SERVICE BULLETIN

17DK SEAL LEAK POT ASSEMBLY

This bulletin provides information on the redesigned seal oil pot assembly.

FIGURE 1 - NEW STYLE 17DR501-213

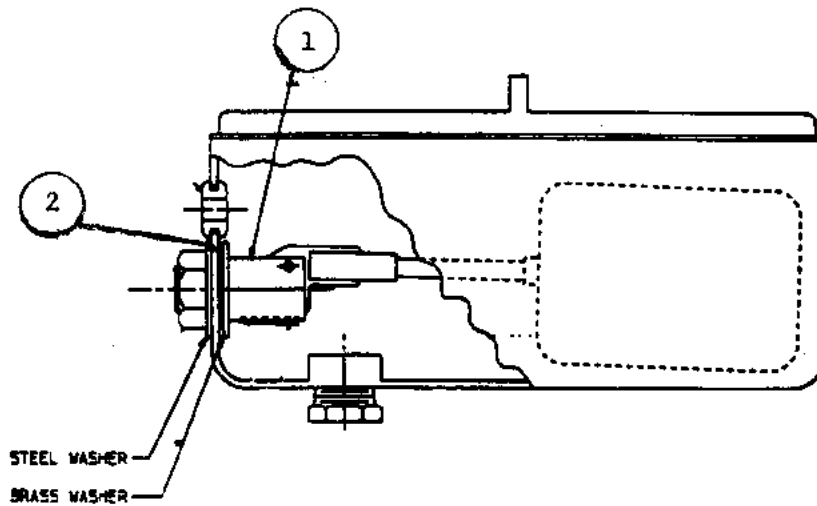
The original seal pot, 17DK111-123, was built from 4" sch. #40 pipe with end plates welded. There was no access to the valve and float assembly. The new style, 17DR501-213, has a removable lid for easy access. See Figure 1. The change went into effect March 1989.

If the valve leaks in the old type seal pot assembly, the entire assembly should be replaced with the new style pot. The new pot may be attached to the motor support frame or to the unishell with a field fabricated mounting arrangement.
